WATTS BAR NUCLEAR PLANT

CONTAINMENT ISOLATION

Corrective Action Program Plan

Revision 0

UPGRADE RECOMMENDED FOR REACTOR COOLANT PUMP SEAL INJECTION LINES

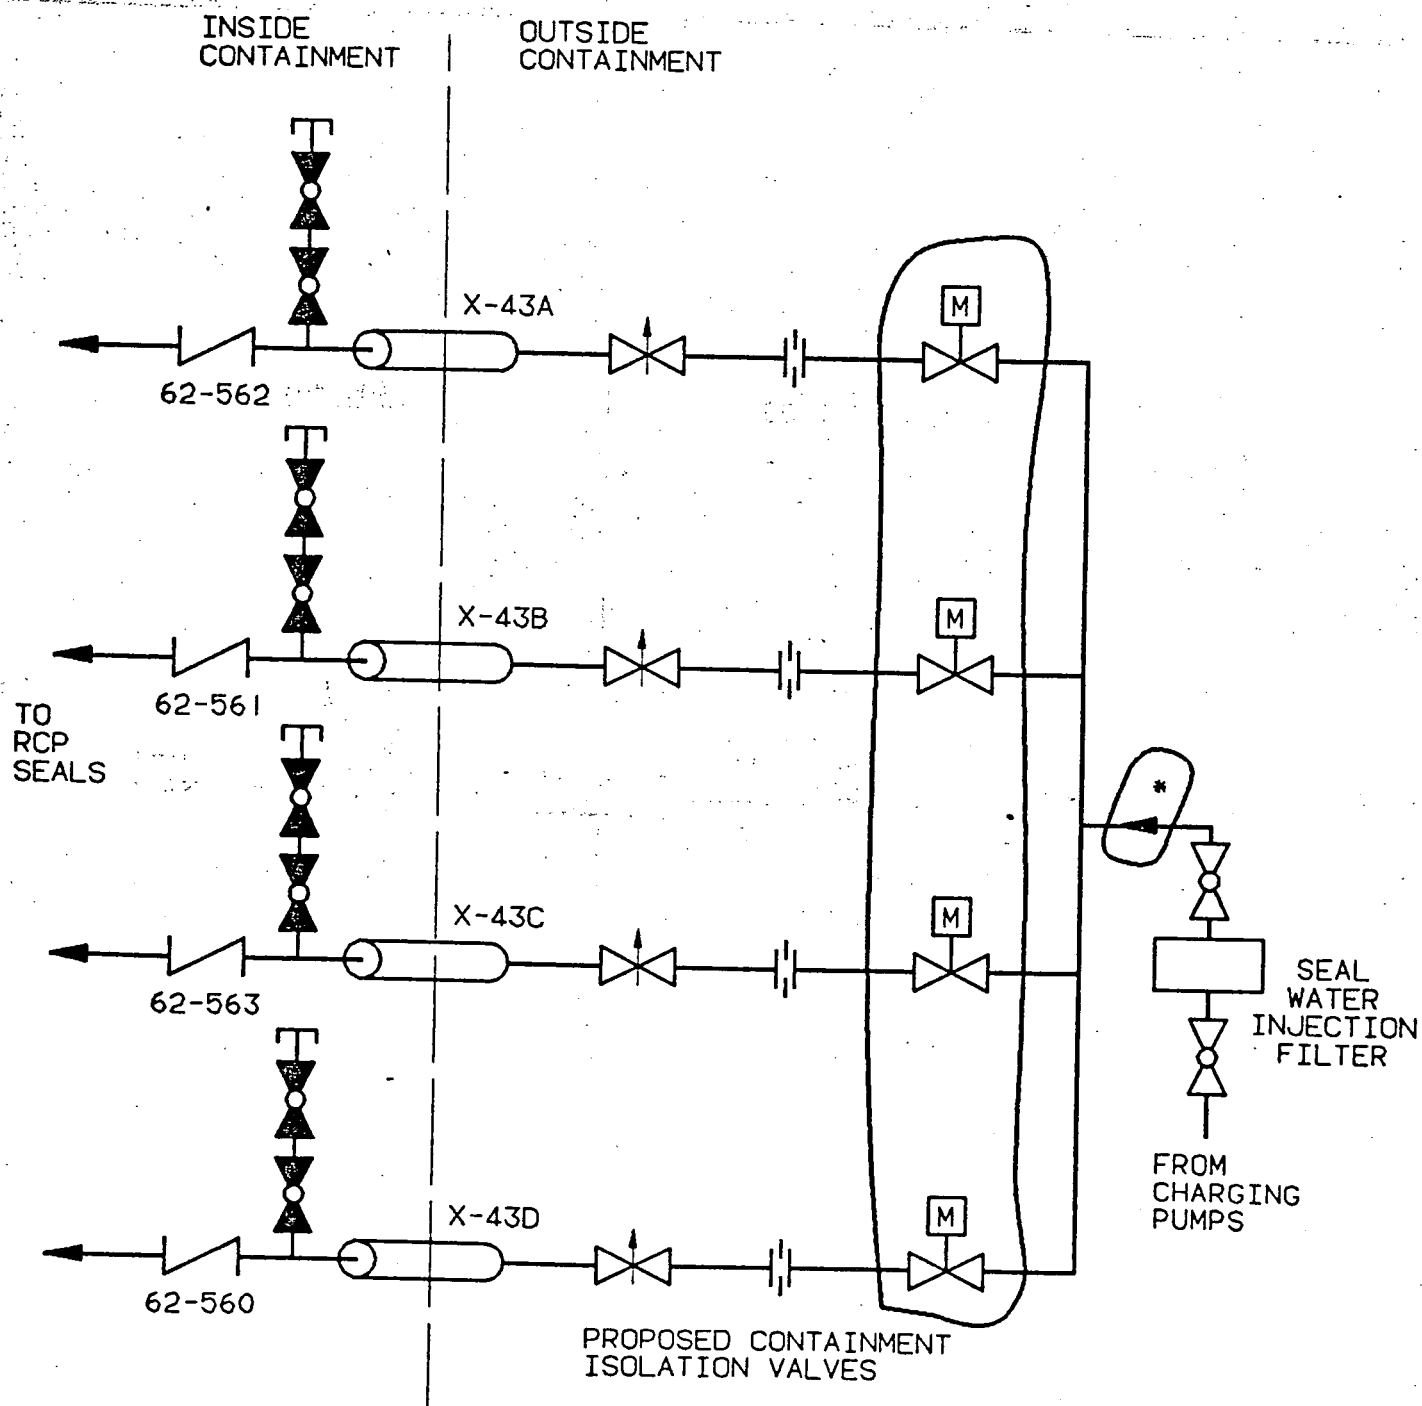
- 62-560 THRU 563 CURRENTLY DESIGNATED AS INBOARD ISO VAVLES
- ADD INDIVIDUAL REMOTE MANUAL OUTBOARD VALVES OR SINGLE R.M. OUTBOARD VALVE IN COMMON HEADER AT *.
- EITHER ADDITION BRINGS LINE INTO COMPLIANCE WITH GDC 55 VIA SRP 6.2.4

UPGRADE RECOMMENDED FOR HYDROGEN ANALYZER LINES

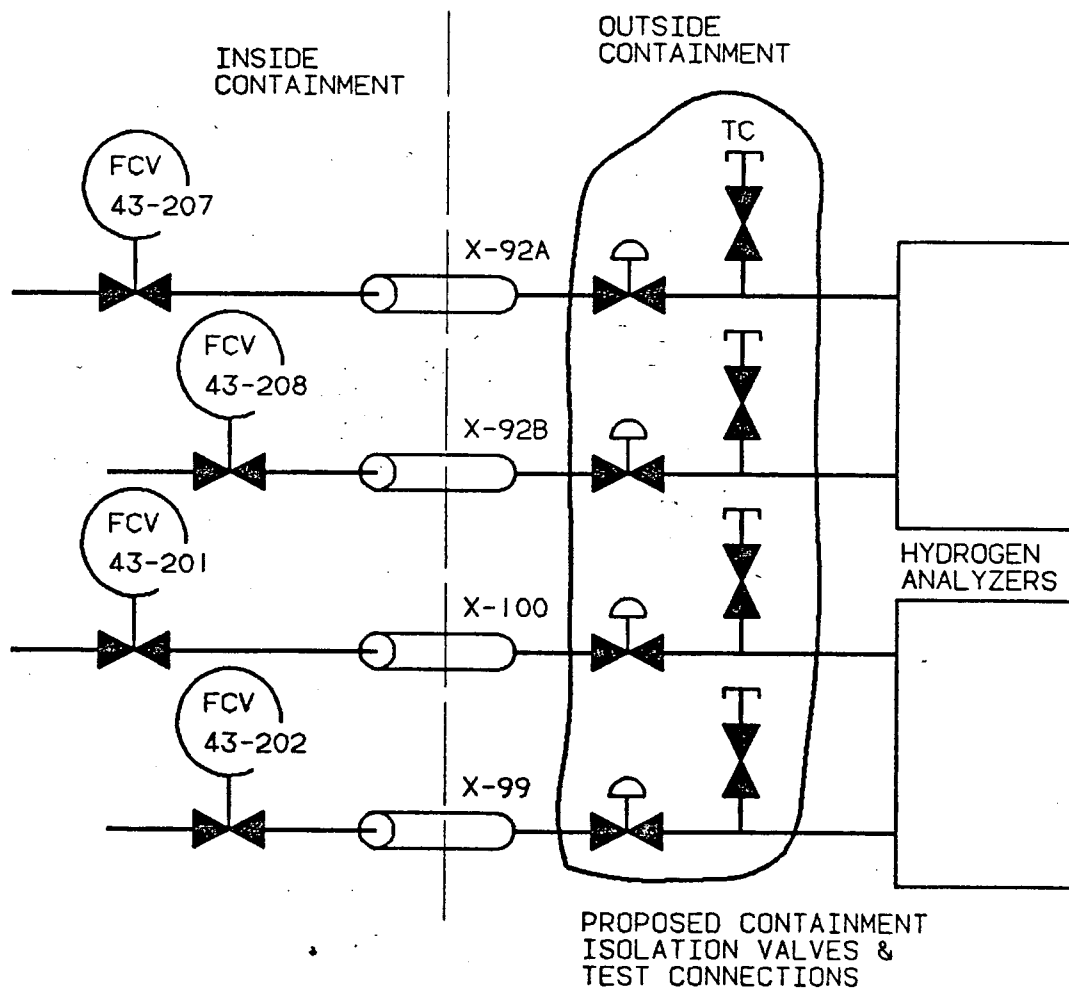
- INBOARD FCV's CURRENTLY DESIGNATED AS INBOARD ISO VALVES
- PREVIOUSLY CONSIDERED CLOSED SYSTEM OUTSIDE CONTAINMENT
- ADD INDIVIDUAL REMOTE MANUAL OUTBOARD VALVES AND TEST CONNECTIONS VIA CAQR WBP 880279
- BRINGS LINE INTO COMPLIANCE WITH GDC 56 VIA SRP 6.2.4

UPGRADE RECOMMENDED FOR RADIATION MONITORING LINES

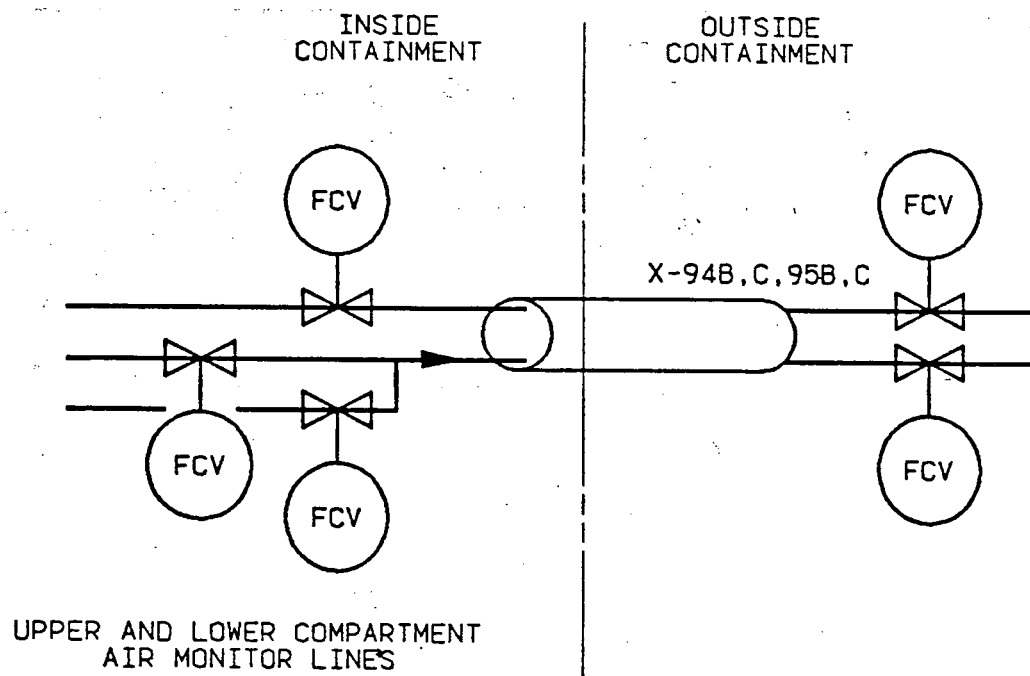
- TVA CLASS C FCV'S INBOARD AND OUTBOARD ARE CURRENTLY DESIGNATED CONTAINMENT ISOLATION VALVES
- CLASSIFICATION TO BE UPGRADED VIA CAOR - WBP880351
- CLASS UPGRADE SATISFIES SRP 6.2.4 QUALITY GROUP REQUIREMENTS
